November 2016 Progress

Foundation Wall Fix Required At Mechanical Shaft

Concrete Mudmat For Loading Dock Foundations
(Pictured Left)

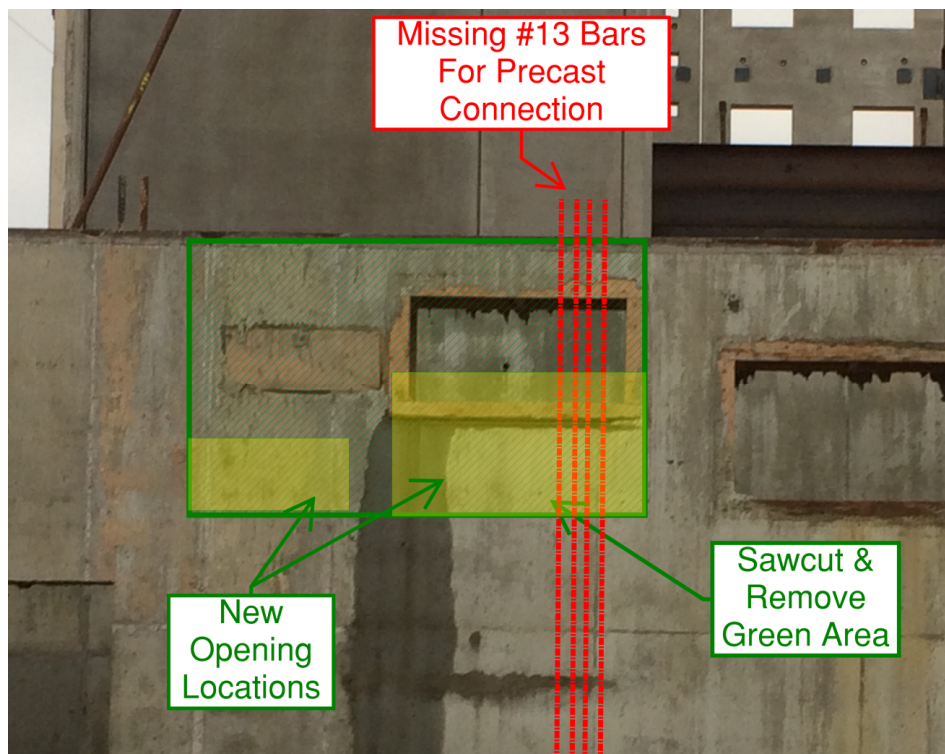
Electrical Room Underslab Rough In
(Pictured Above)
